PETITION TO AMEND

DONALD VON RAESFELD POWER PLANT (02-AFC-3C)

SUBMITTED TO: CALIFORNIA ENERGY COMMISSION

SUBMITTED BY: SILICON VALLEY POWER

Figure 1 - Preferred route from Cogen Warehouse at 524 Robert Ave to DVR Power Plant at 850 Duane Ave.

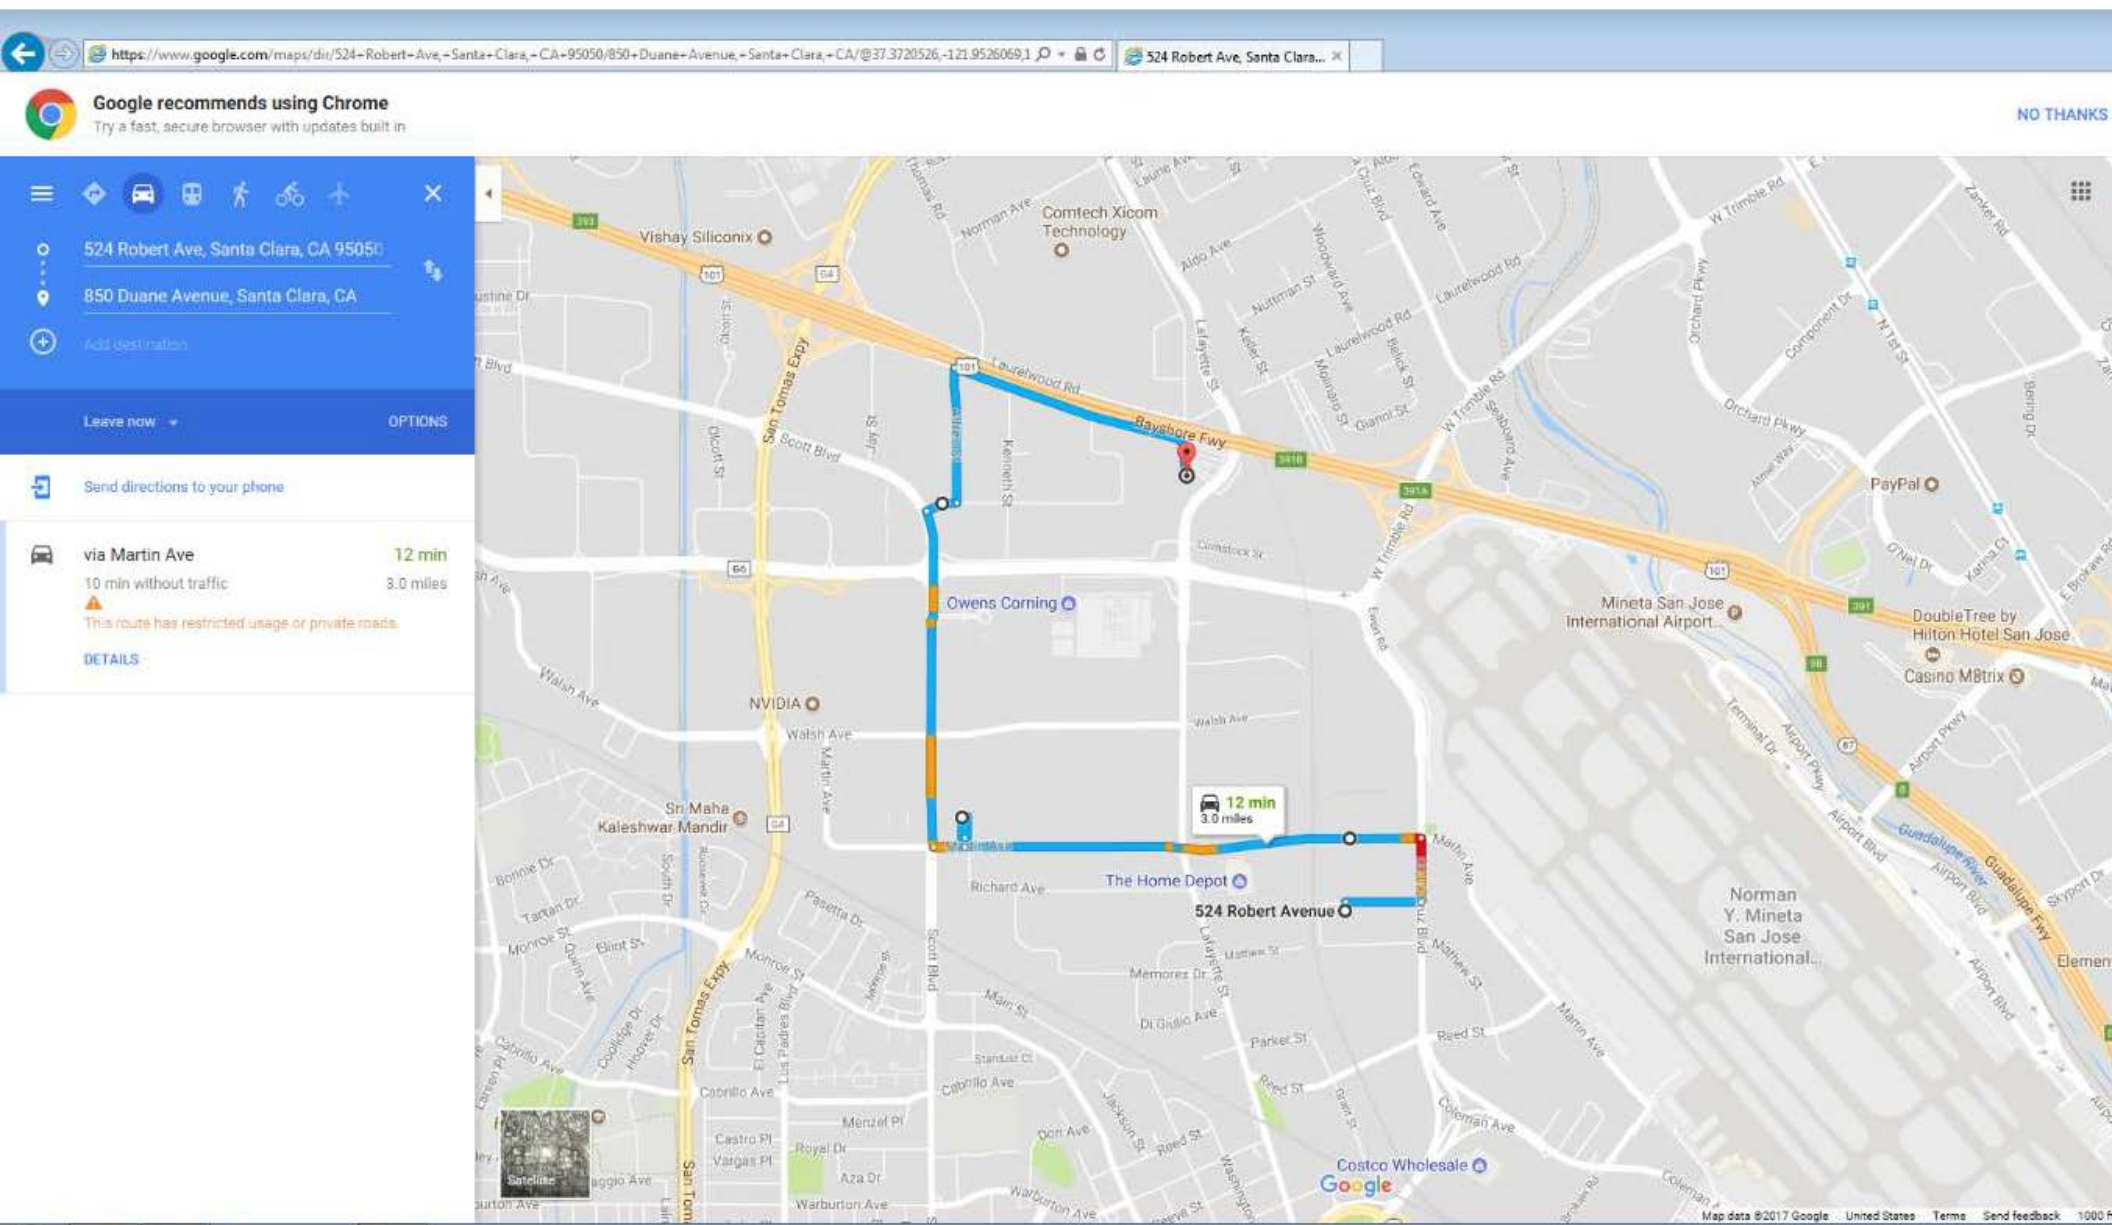
Both the crane and trailer follow the route to the DVR site, shown on Figure 1, and then prepare for the turbine exchange. The turbine that was removed is placed inside the same container the spare was delivered in and is hauled away on the low-boy trailer to a certified maintenance shop to work on the turbine.

Delivery of the spare turbine to the DVR will not create traffic impacts because the preferred route shown on Figure 1 will be used. This route was chosen to immunize impacts by avoiding the left-hand turn from Lafayette Street onto Duane Avenue, where oncoming traffic is often fast and difficult to see in time to navigate the left turn.

Silicon Valley Power will use the preferred route above when shipping the spare DVR turbine to the DVR Power Plant. The purpose for choosing this route is to avoid the left-hand turn from Lafayette Street onto Duane Ave., where oncoming traffic is often fast and difficult to see in time to navigate the left turn.
